Product Change Notification

Product Group: TC/Thursday July 30, 2026/PCN-TC-016-2026-REV-0

Enhanced T55/T56 multi anode D-case capacitor construction

T55 and T56 series case D – Old construction

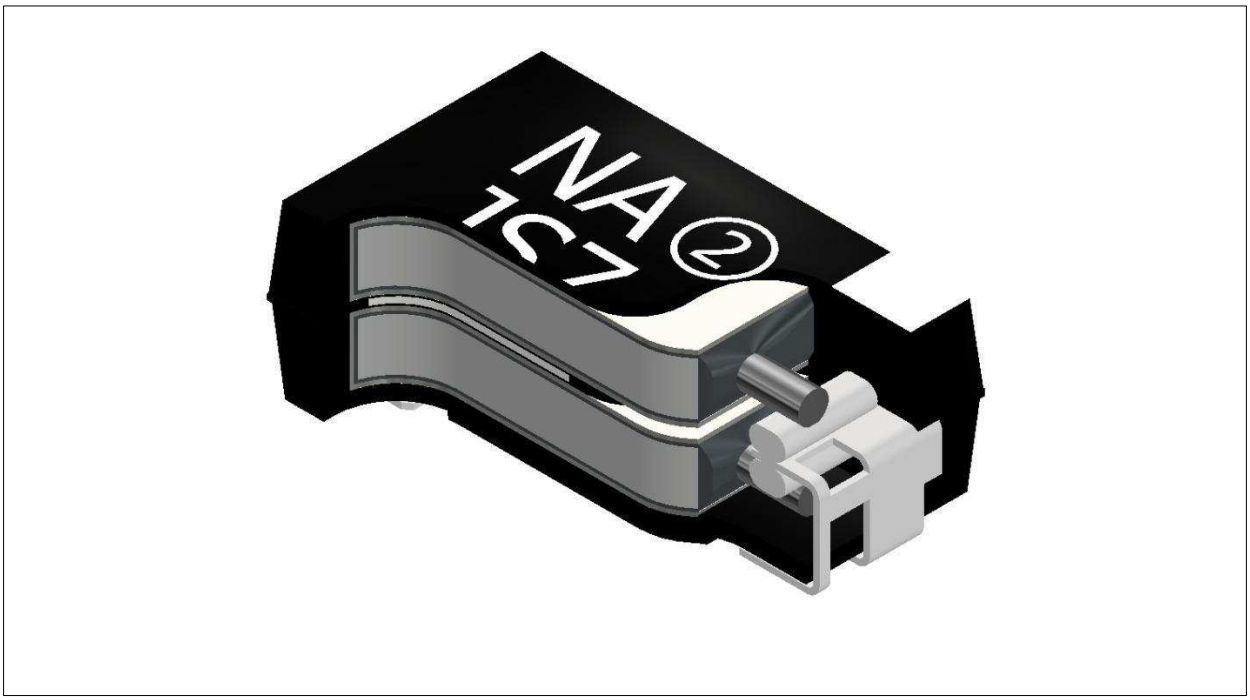
Description of Change: Redesigned dual anode architecture with optimized anode orientation changed from stacked to side-by-side.

Reason for Change: Side-by-side orientation of anodes provides direct connection to a lead frame, improved manufacturability and lower ESR values.

T55 and T56 series case D – New construction
